Planning Commission Staff Report

Project Type: Site Development Section Plan

Description: **Drury Plaza Hotel (Hyatt Place):** Site Development Section Plan, Landscape Plan, Lighting Plan and Architectural Elevations for a 4.851 acre tract of land zoned “PC” Planned Commercial District located adjacent to Chesterfield Mall at the intersection of Clarkson Road and U.S. Highway 40/Interstate 64.

SITE DEVELOPMENT SECTION PLAN PHASE III - HYATT PLACE AT DRURY PLAZA

Sheet Title: Landscape Plan
Sheet No: L1.0
Date: 08/30/11
Job #: 615.024

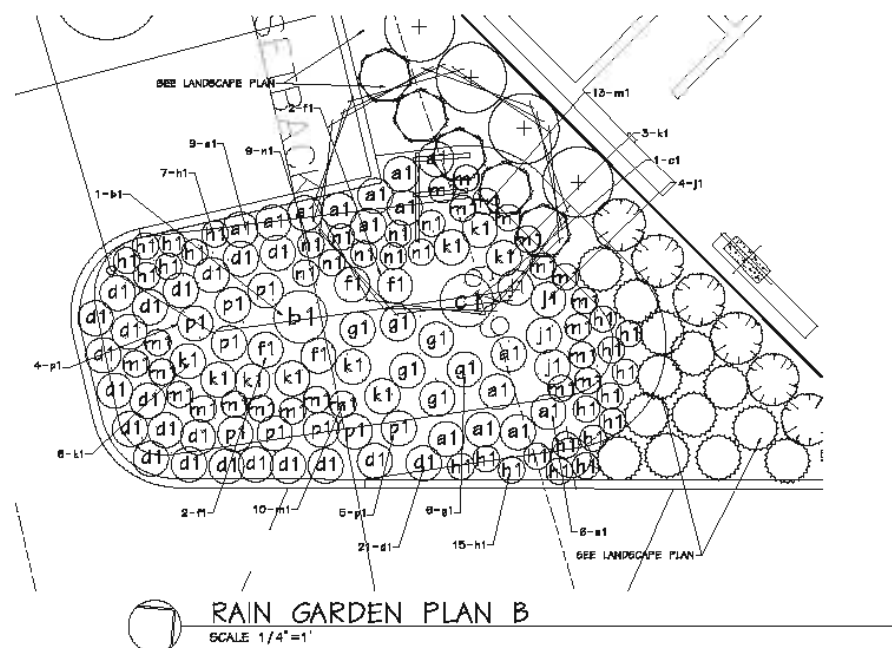
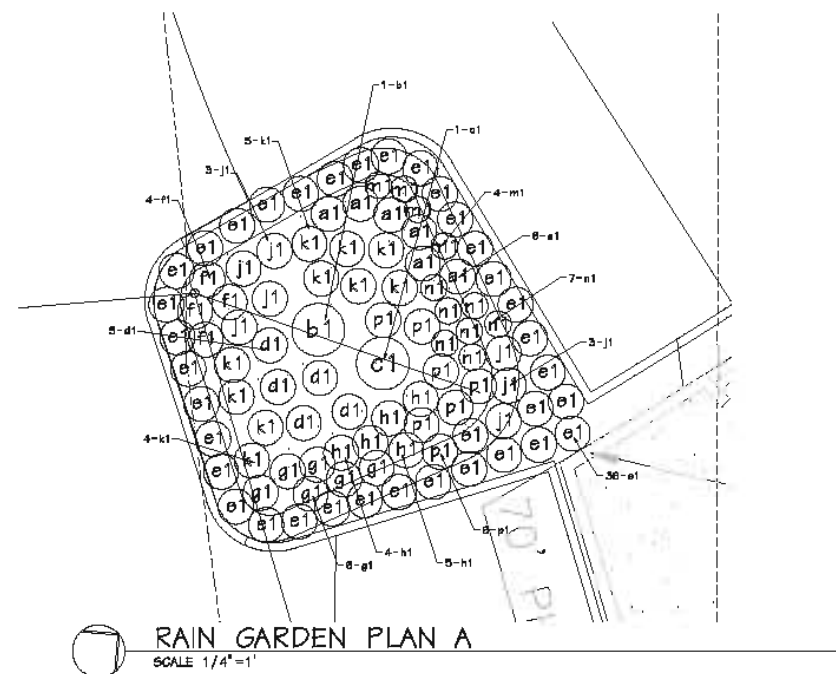
1. Petitioner is to incorporate multiple architectural planters at the entrance to soften the entry and bring in human scale.
2. Plantings around the edge of the structure should be of a type which provides a taller maturity height. Staff is to work with the petitioner on the type of plants.
3. Any future satellite dishes, cell towers, etc., being added to the roof must be screened.

A motion was passed to forward the project to Planning Commission for approval by a vote of 5-0. The landscape plan has been amended to include in-ground landscape beds around the entrance to the hotel rather than the movable planters. The plant types around the edge of the structure have been amended with a type that will grow to a taller mature height. The amended landscape plan has been included in the Planning Commission packets. Any future addition of telecommunications facilities would need to meet the requirements of the telecommunications ordinance in regard to the type and method of screening.
